R05JS

July 15, 2005

RECALL R05JS
INSTRUCTIONS FOR REPLACING DASH WARNING LIGHT OVERLAY DECAL

Overlay decal

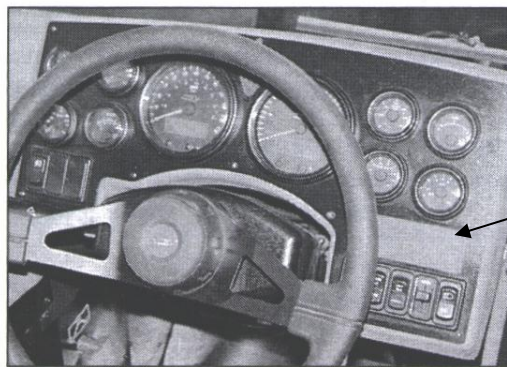
The nonconformance relates to the brake dash warning light indicator. The original dash warning light indicator displays an International symbol on the brake warning light indicator whereas FMVSS 571.105 requires the words "BRAKE PRESSURE" to be displayed. The operator may not recognize the International symbol as warning indicating a problem in the hydraulic brake system which could result in the potential for vehicle crash should the warning not be heeded

- 1. Locate the 12-position telltale overlay in the lower right side of the instrument panel.**

- 2. Using a sharp object, such as a razor knife, carefully peel one side of the overlay out of the recessed pocket. Take care to avoid damaging the front of the dash panel.**
- 3. Remove and discard the old overlay.**
- 4. Carefully peel the protective backing from the new overlay. Avoid touching the back of the overlay as this may affect the adhesion.**
- 5. Ensure the overlay is right side up by holding it up to the light.**
- 6. Place one side of the overlay into the recessed pocket and lightly press in the rest of overlay until it is evenly located in the recessed pocket.**
- 7. Cycle the dash ignition to ensure the overlay was properly installed.**
- 8. Rub the overlay to ensure it is mounted securely using a clean, soft cloth.**
